Emeric Construction Submittal # 0500-1
 This drawing or submittal has been reviewed for compliance with plans and specifications and coordination with the work of others. Approval does not relieve supplier or subcontractor of responsibility for errors, omissions, or non-compliance with the contract documents.
 Approved Approved as noted
 Revise and resubmit
 By: *[Signature]* Date: 1-26-95

FABRICATION PRODUCTS
 6131 NE. 63 rd. Street
 Vancouver, WA 98661
 Phone (360) 696-1324

DRAWN BY	DATE	CUSTOMER	CITY OF McMinnville	CONTRACT NO.
CHECKED BY	DATE	STRUCTURE	McMinnville Comm. Center	DWG NO.

Emerick Construction Submittal # 0500-2
 This drawing or submittal has been reviewed for compliance with plans and specifications and coordination with the work of others. I approved does not relieve supplier or subcontractor of responsibility for errors, omissions, or non-compliance with the contract documents.
 Approved Approved as noted
 Advise and resubmit
 By: [Signature] Date: 2-20-95

3 A^P ~ COLUMN ~ ONE REQ'D. (AS SHOWN)
3 A^L ~ COLUMN ~ ONE REQ'D. (OPP. HAND)

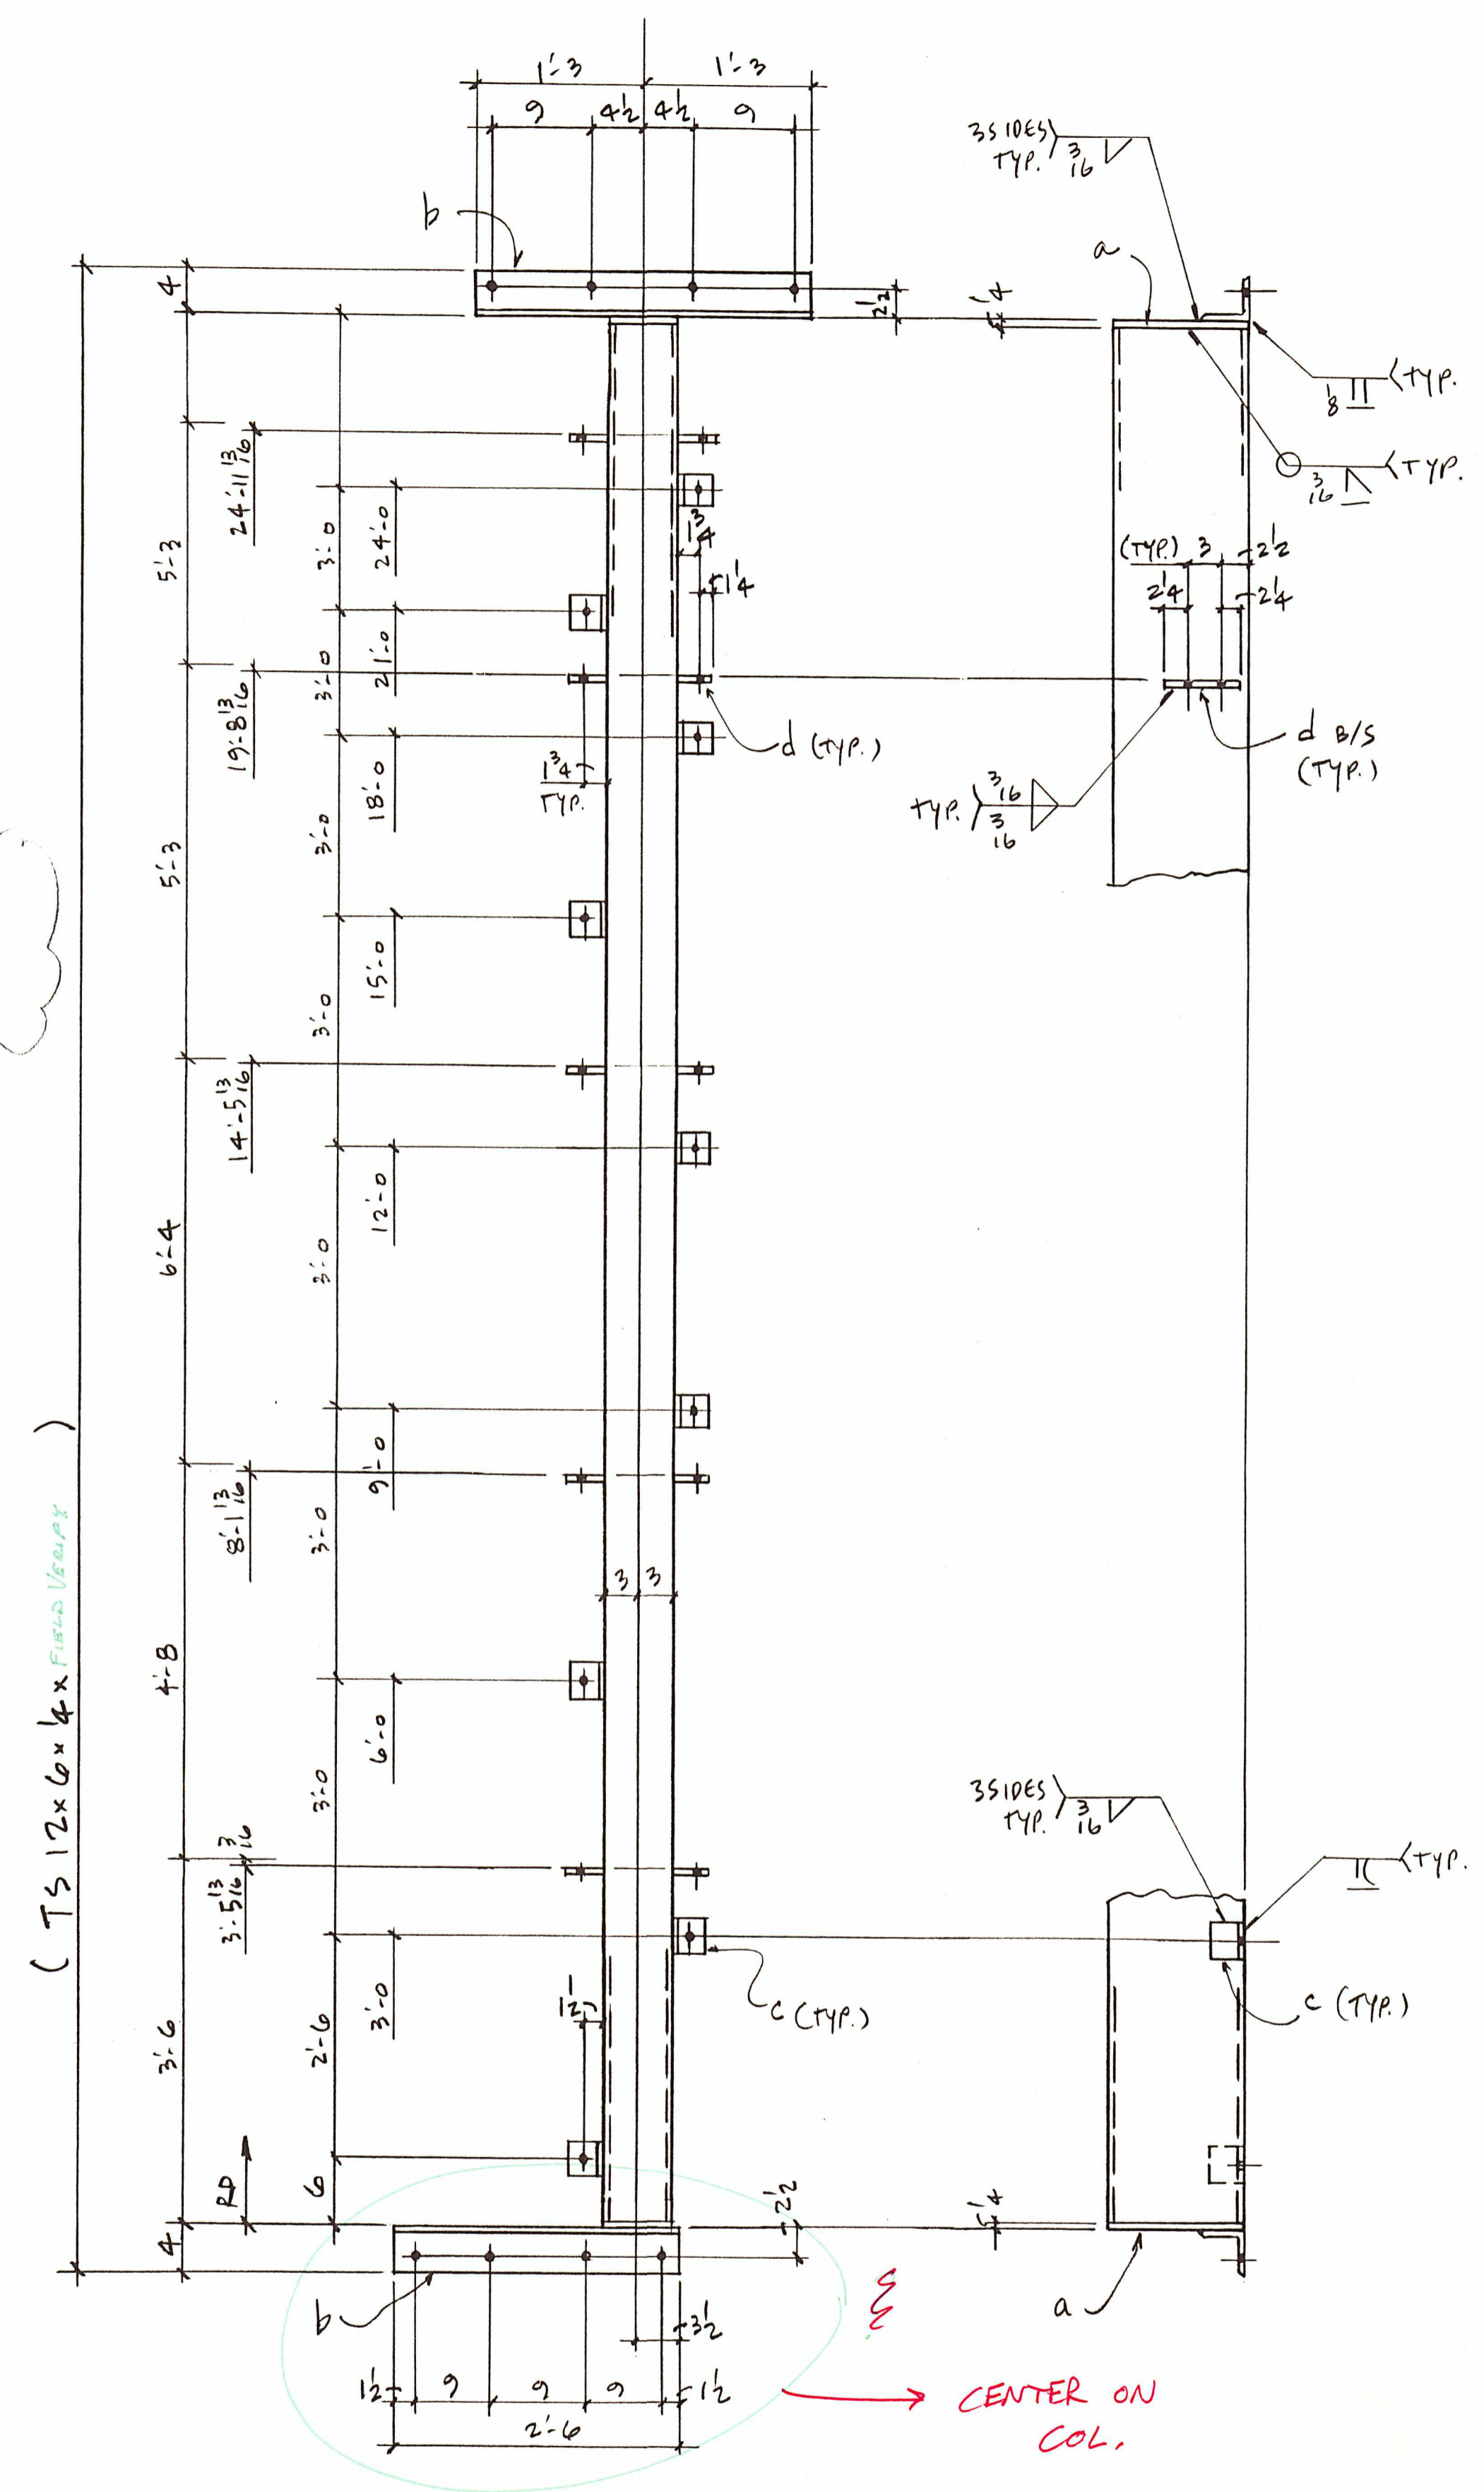
provide

3 B^P ~ COLUMN ~ ONE REQ'D. (AS SHOWN)
3 B^L ~ COLUMN ~ ONE REQ'D. (OPP. HAND)

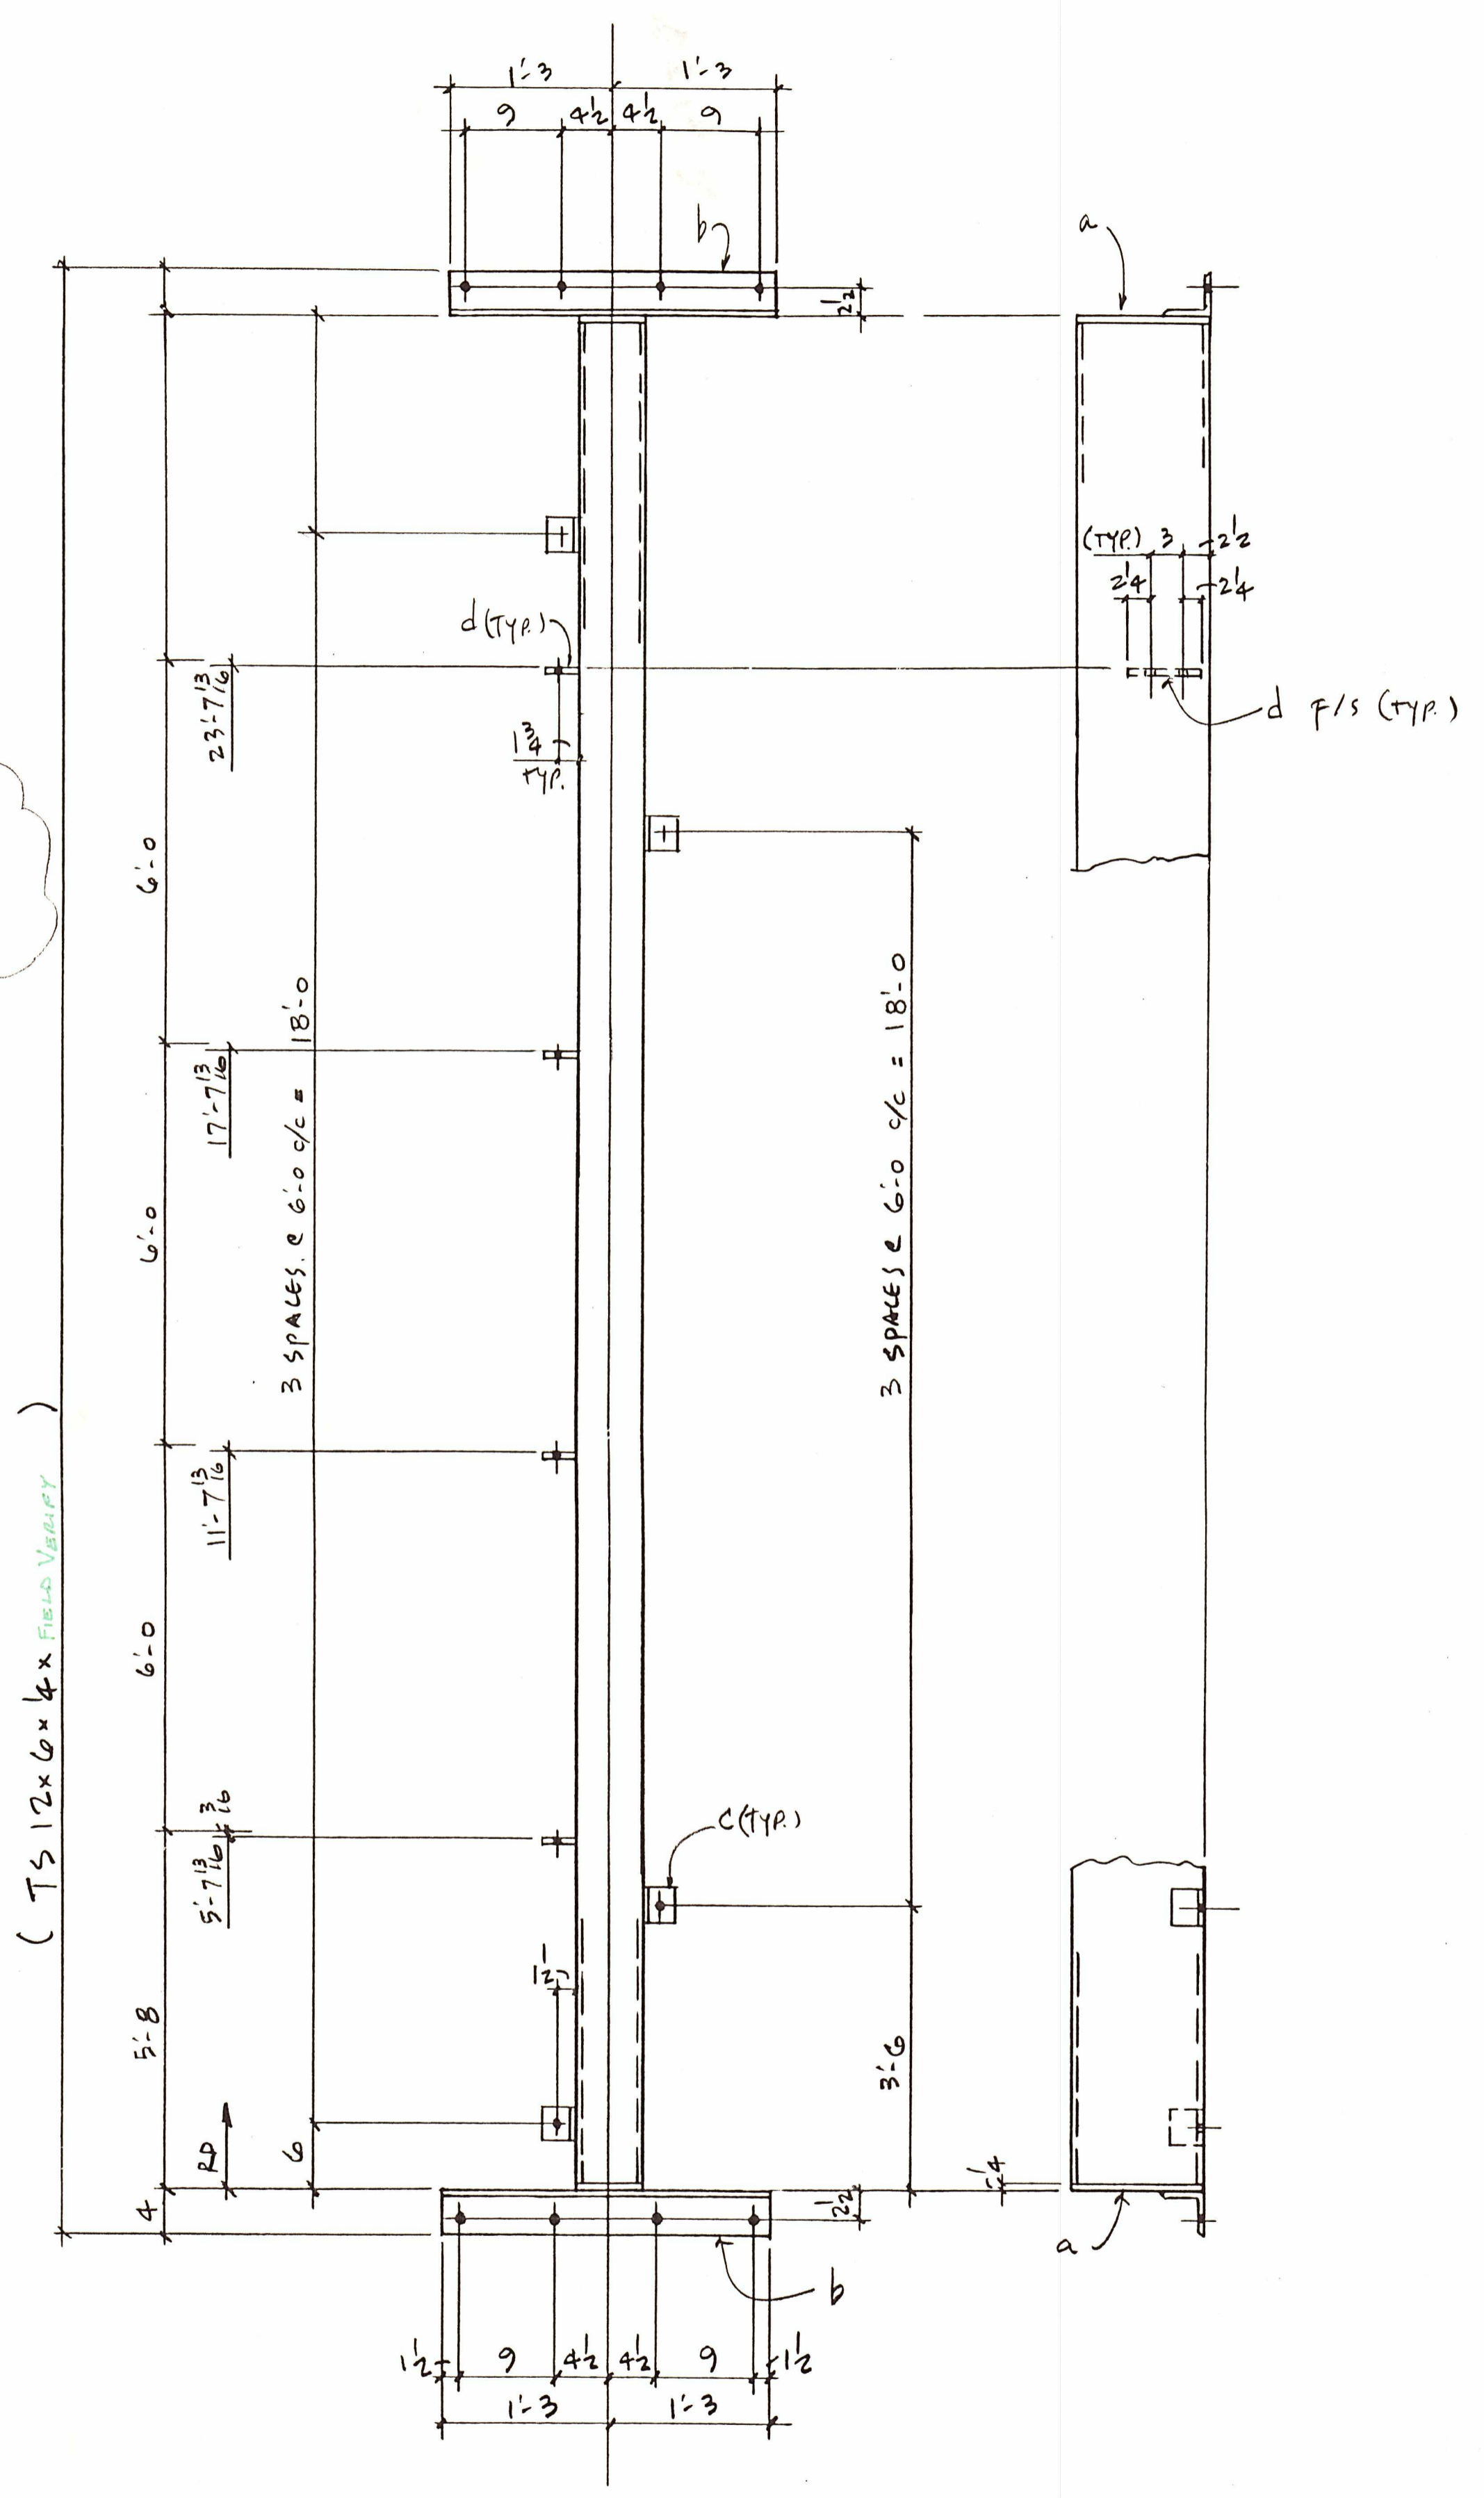
provide
